RE: **Palen Solar Power Project, Docket No. 09-AFC-7**
Responses to January 14, 2010 CEC Workshop Queries
Technical Areas:
Soil & Water Resources (supplemental data for DR-S&W-242)

Palen Solar Power Project

Soil and Water Data Responses to January 14, 2010 CEC Workshop Queries

DR#242 Supplemental---Soil and Water:

DWG: H:\60202528 Solar Millennium\Palen\CADD\Civil\Sheet\conceptual civil plans\C-203 PALENC-PD-105.dwg Layout Name: PD-105 – Plotted by: Gonzales, Tom Date: 1/26/2010 – 1:11 PM
XREFS: xrdp – g-bd_2000 (Drainage) IMAGES: palen.tif – Palen-Exterior-Location_3.jpg

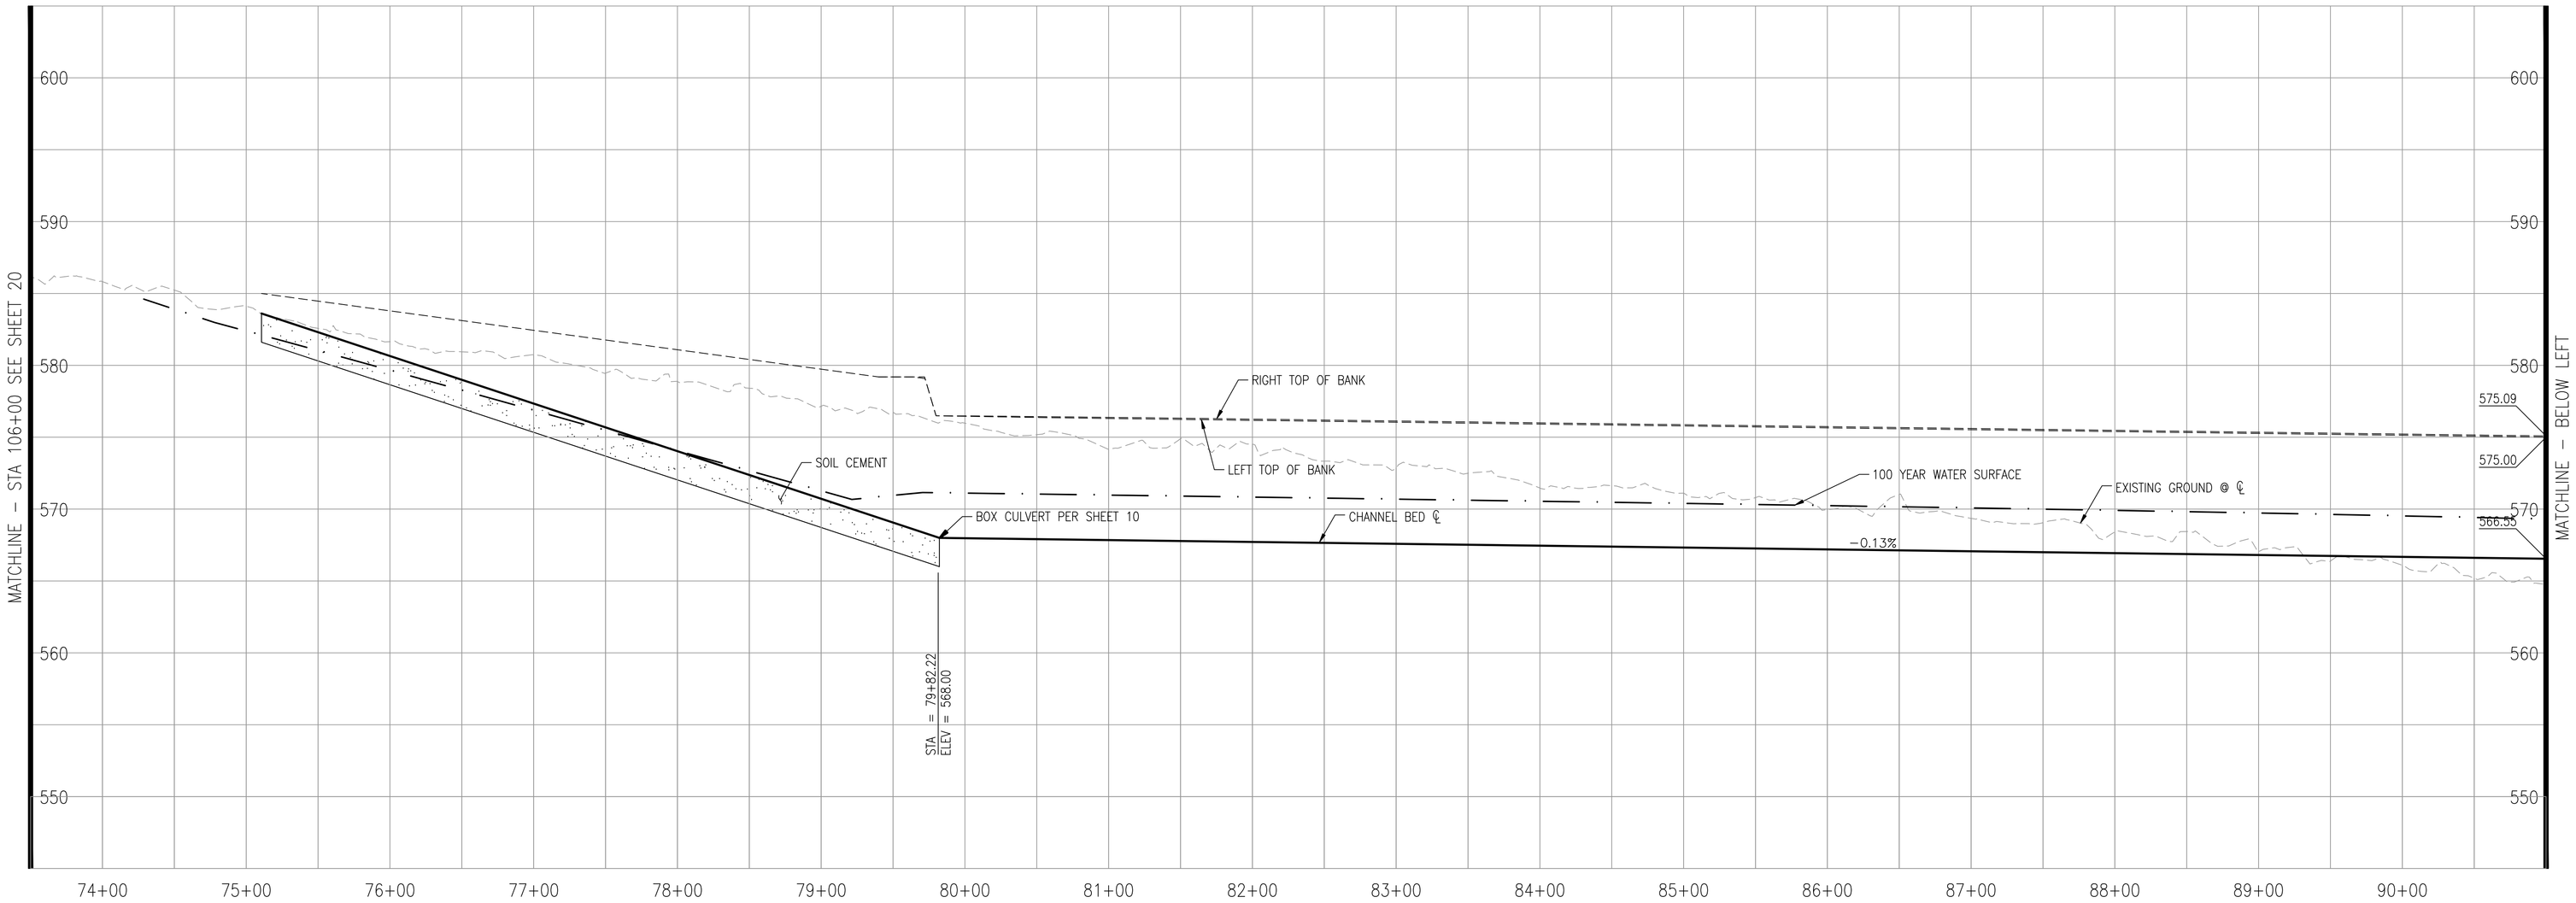
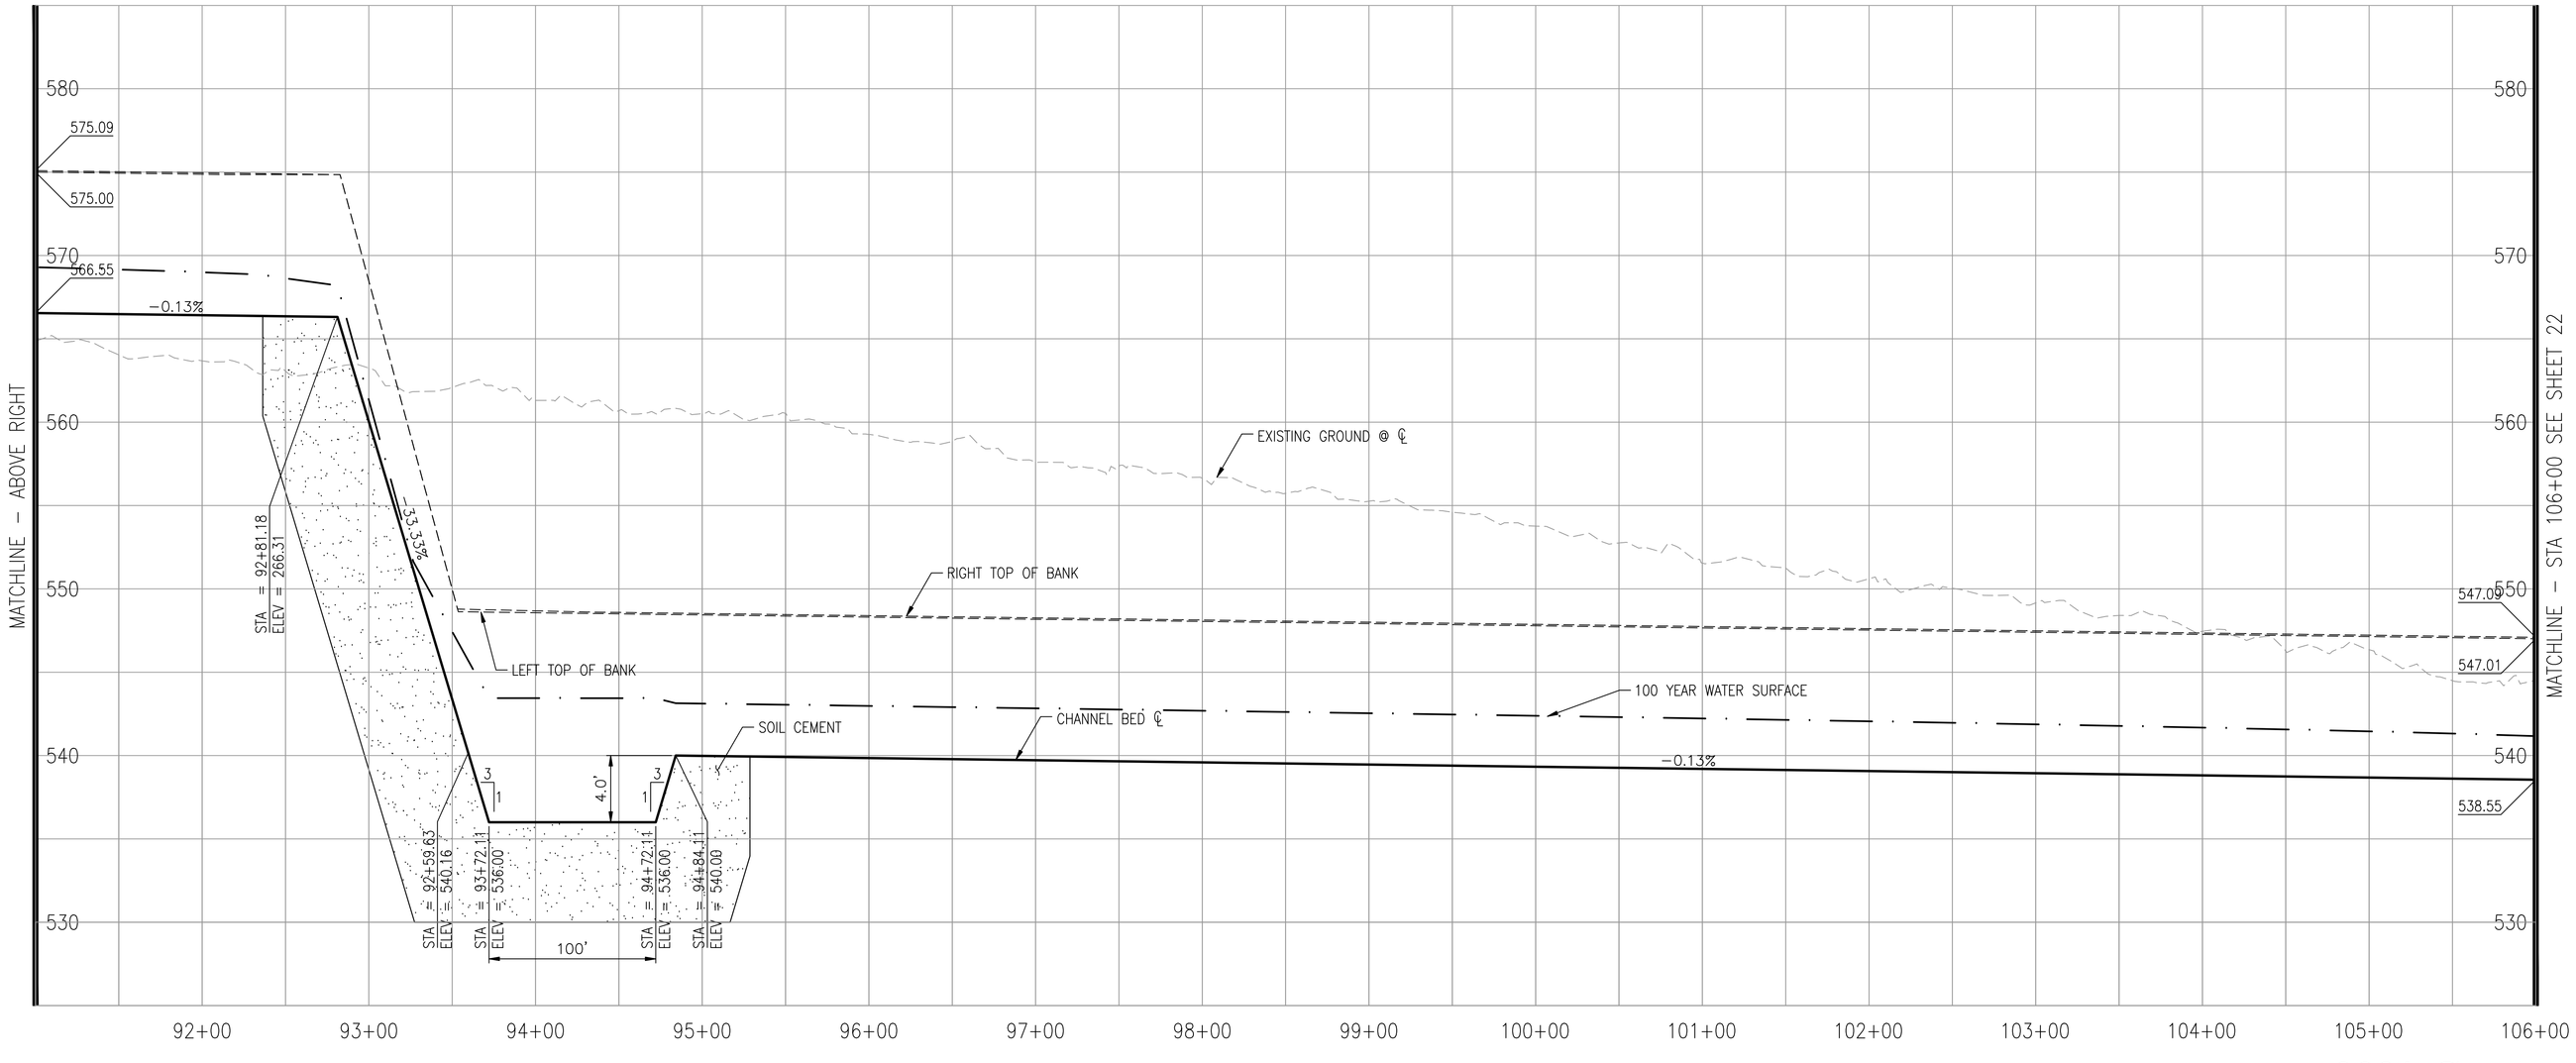
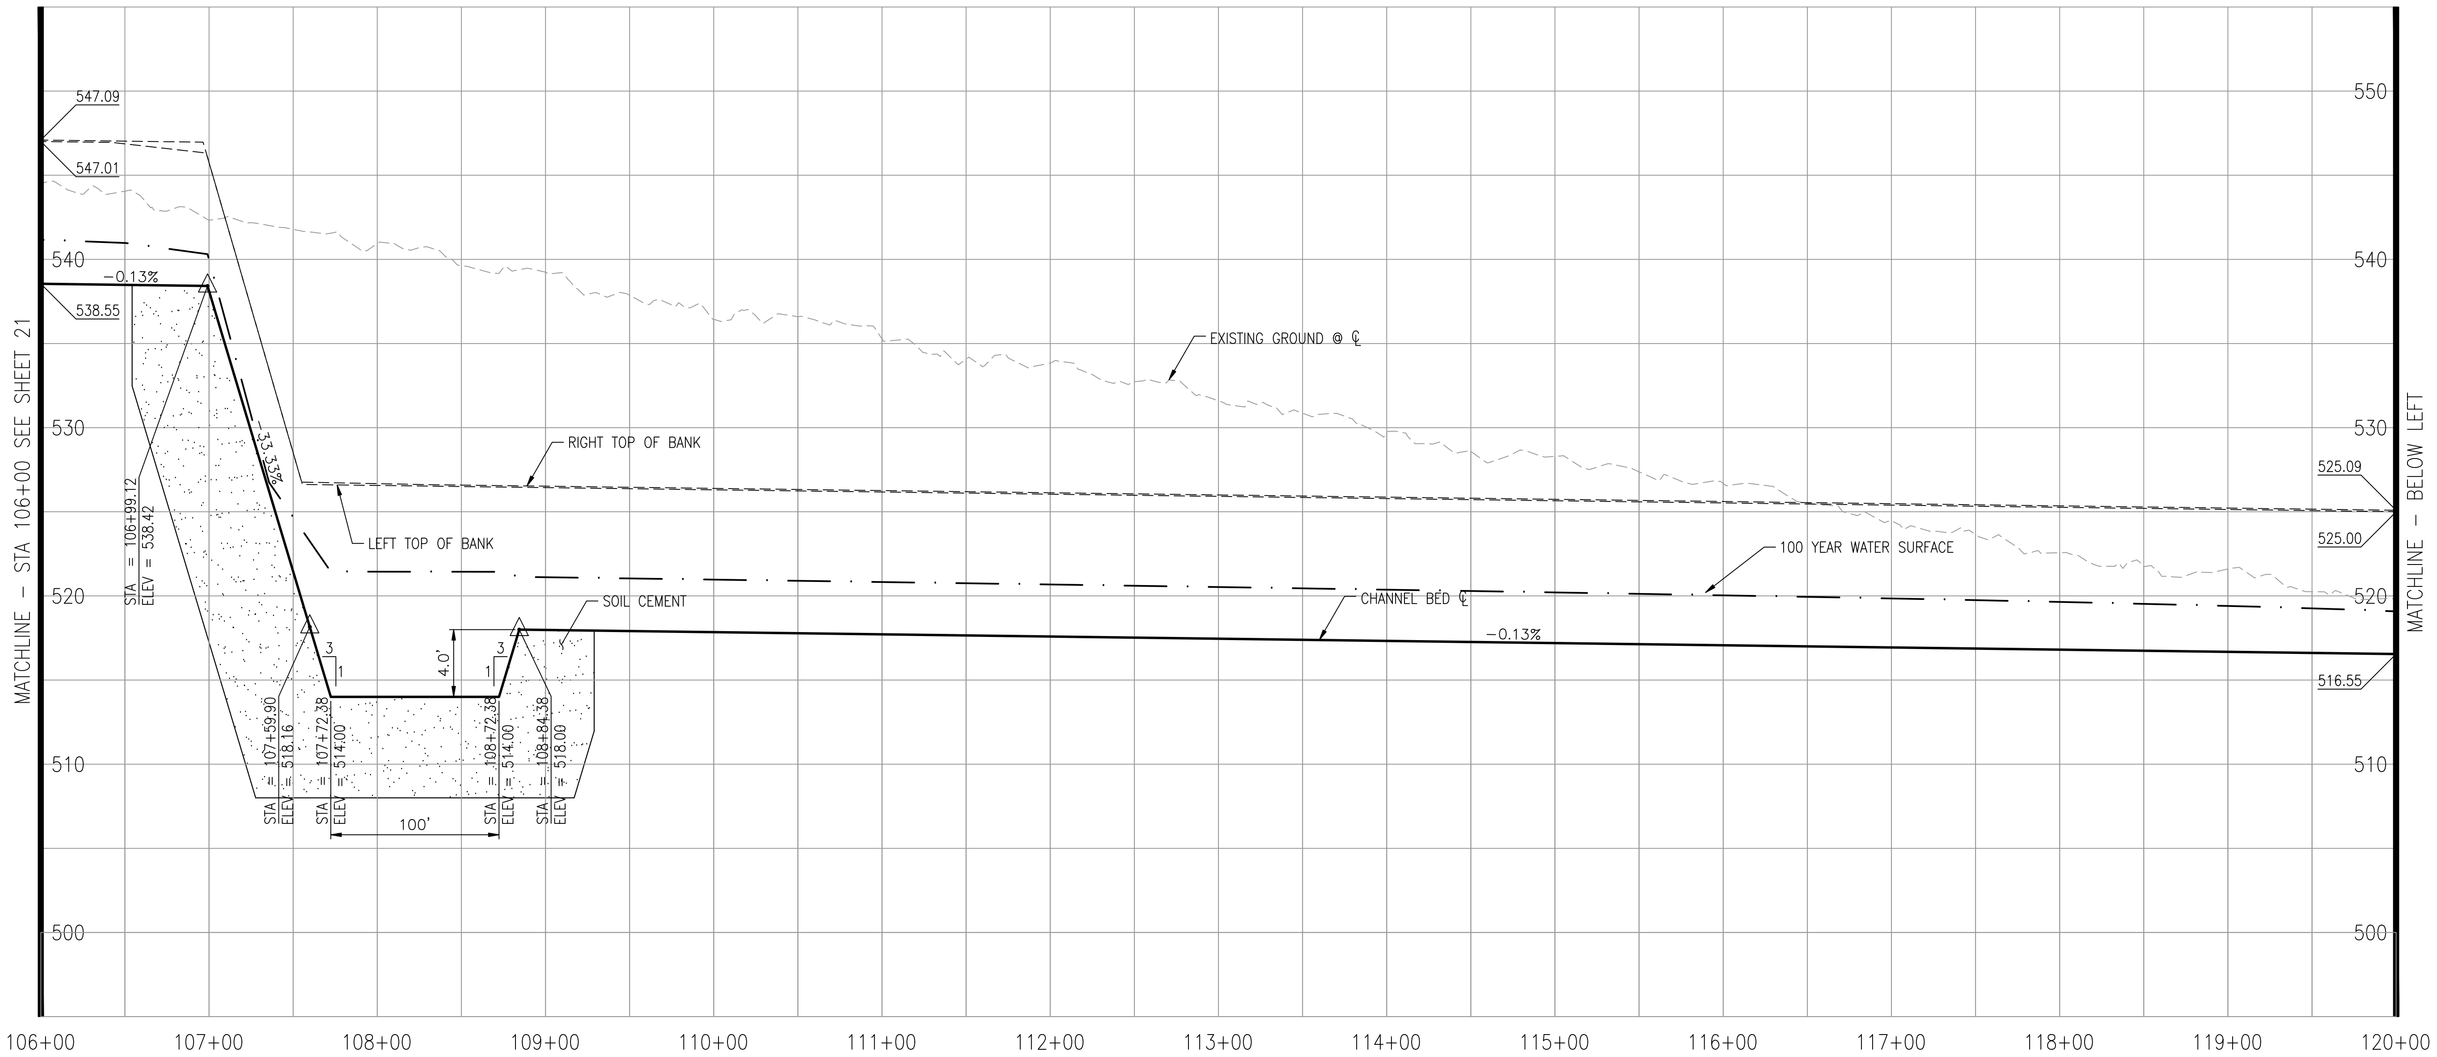
Add 100-yr. water surface elevations on profiles for main channels (both collectors and conveyance).

The 100-year water surface profile has been added to the plans and is provided as part of this response.
